**GARVEY COMMONS/
 SHERBURNE HALL
 ADDITIONS & REMODELING**
 ST. CLOUD STATE UNIVERSITY
 ST. CLOUD MINNESOTA

A-9

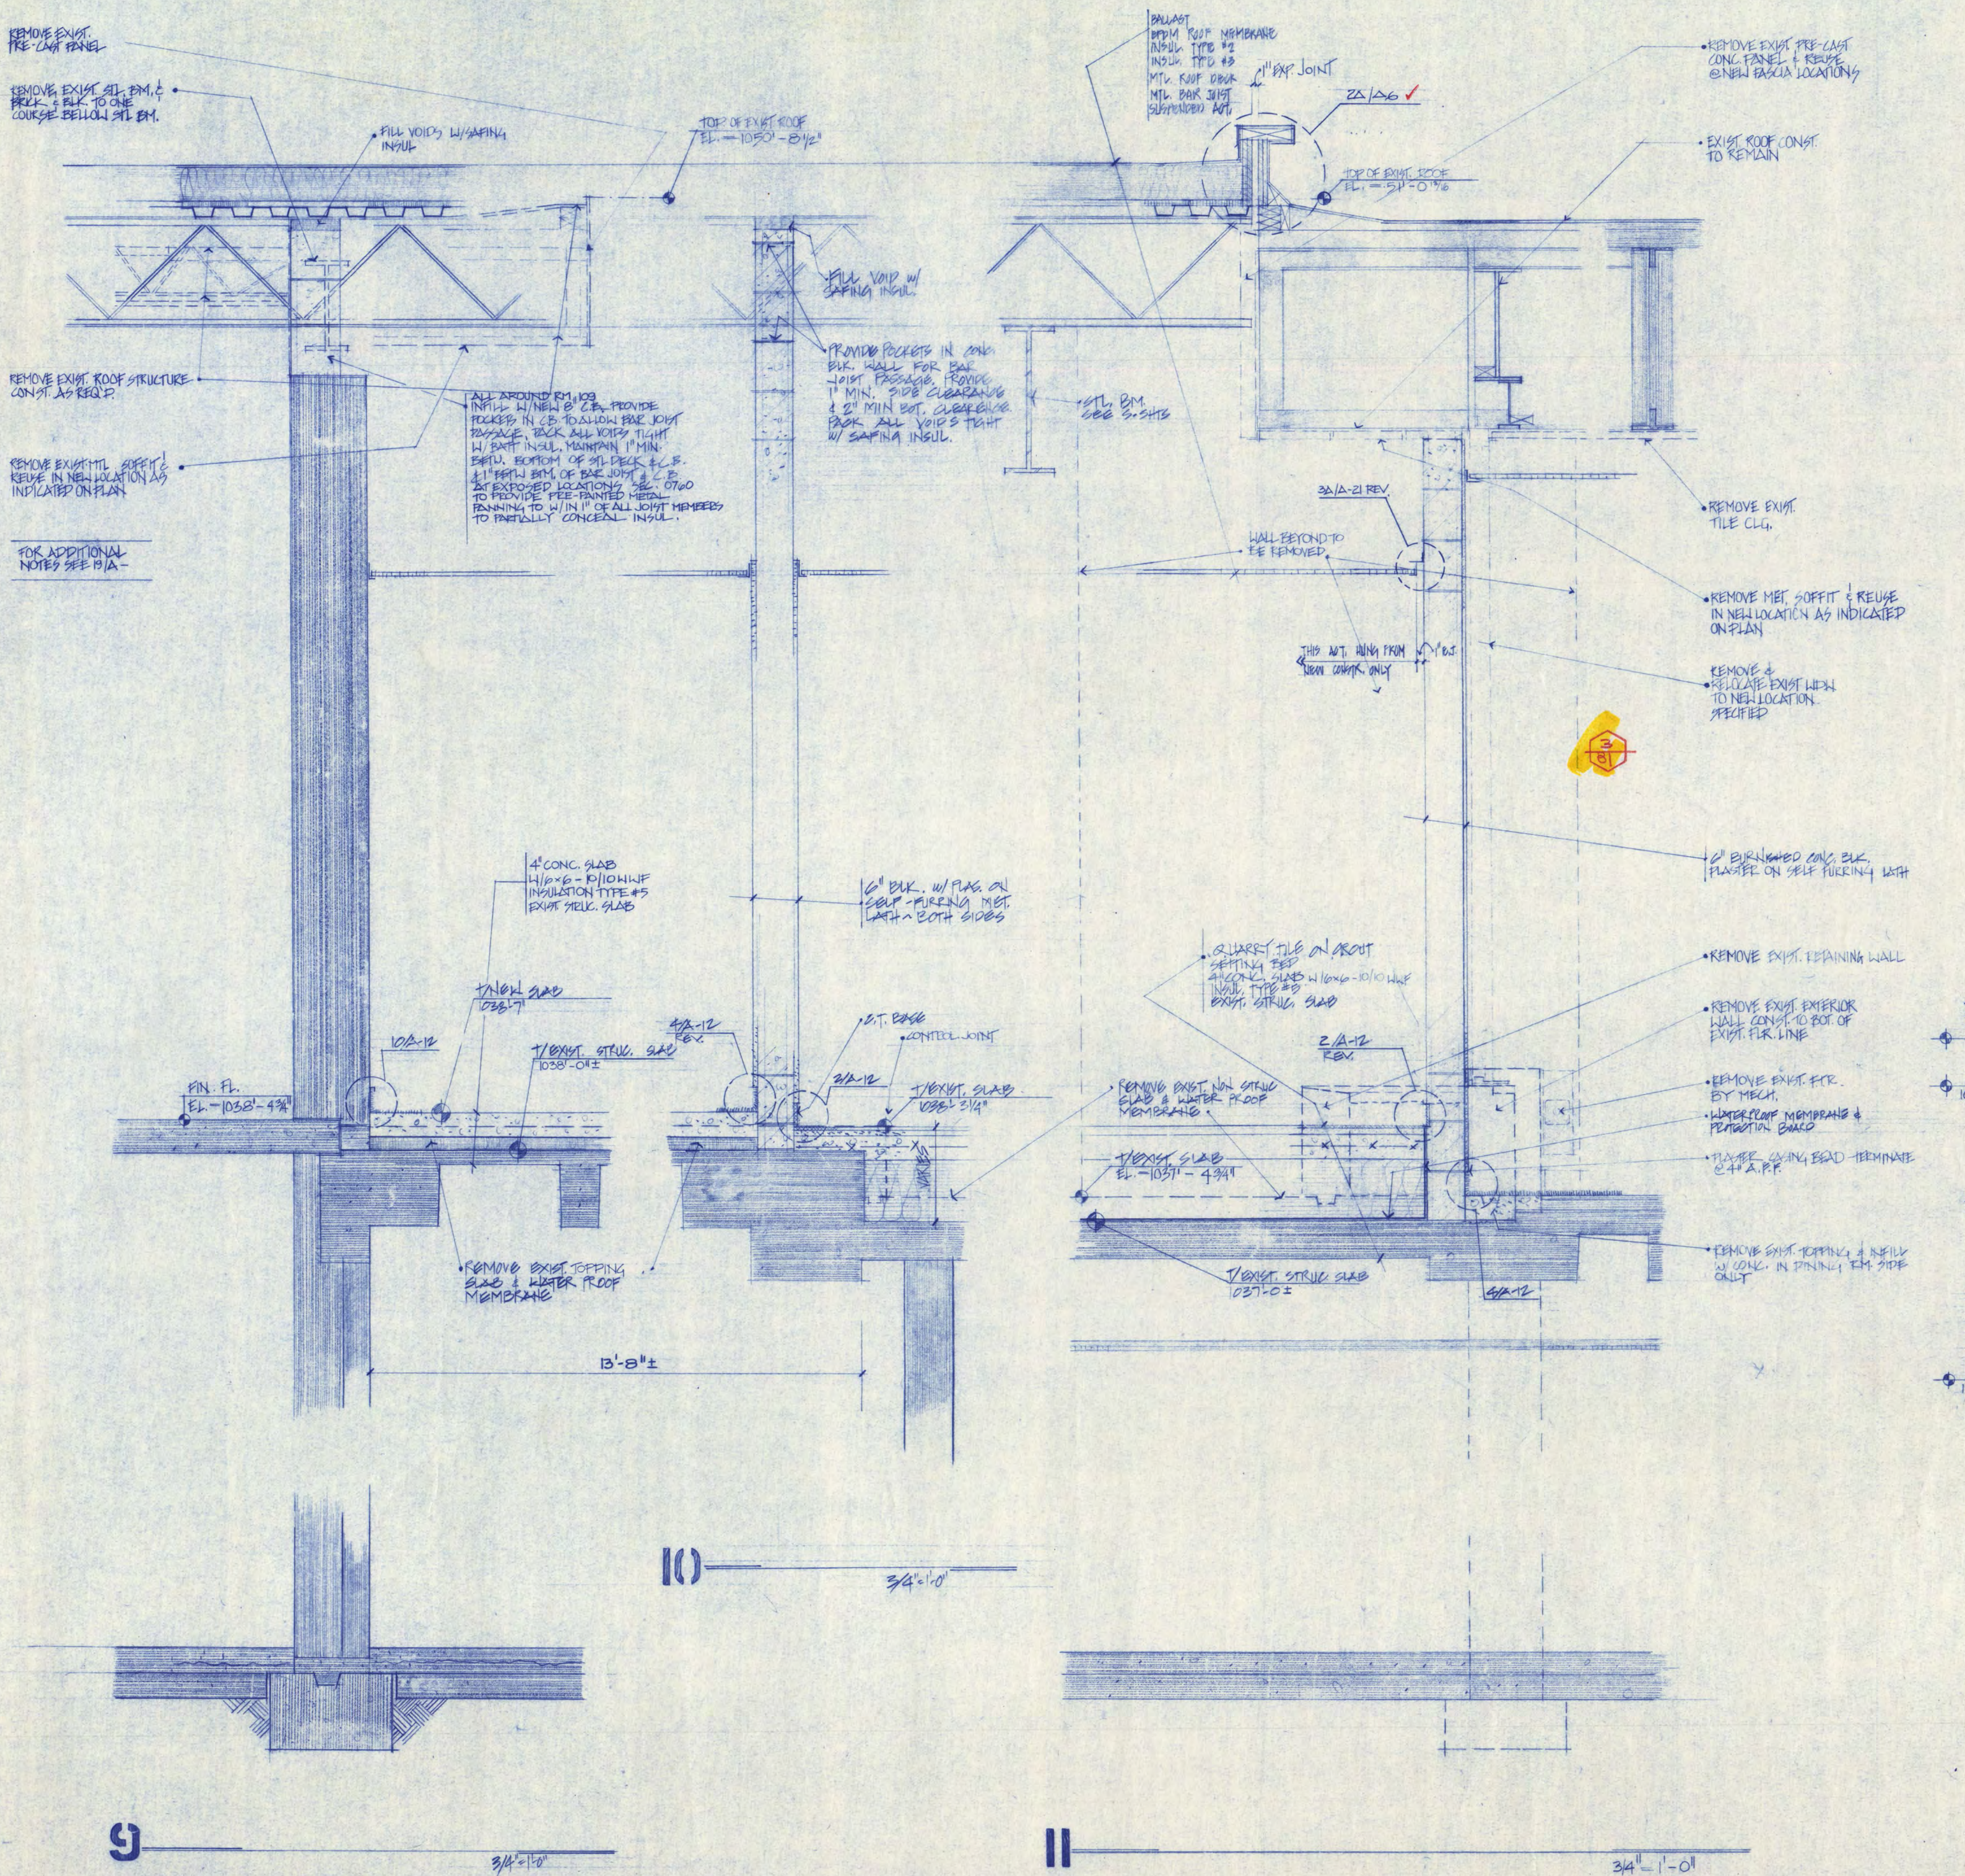
80. Detail 7A: At existing column 58, increase the size of enclosed area around the column to conceal refrigerant piping by the FSEC. The General Contractor shall core drill the existing floor slab at this location for refrigerant piping by the FSEC. Verify location(s) of holes with the Architect.

81. Detail 11: The existing exterior wall at the first floor level which is noted for removal is a cast-in-place concrete and face brick wall similar to Sheet SD-1 issued with this Addendum. The dashed double line and footing at the basement level represent existing columns and footings beyond which are to remain.
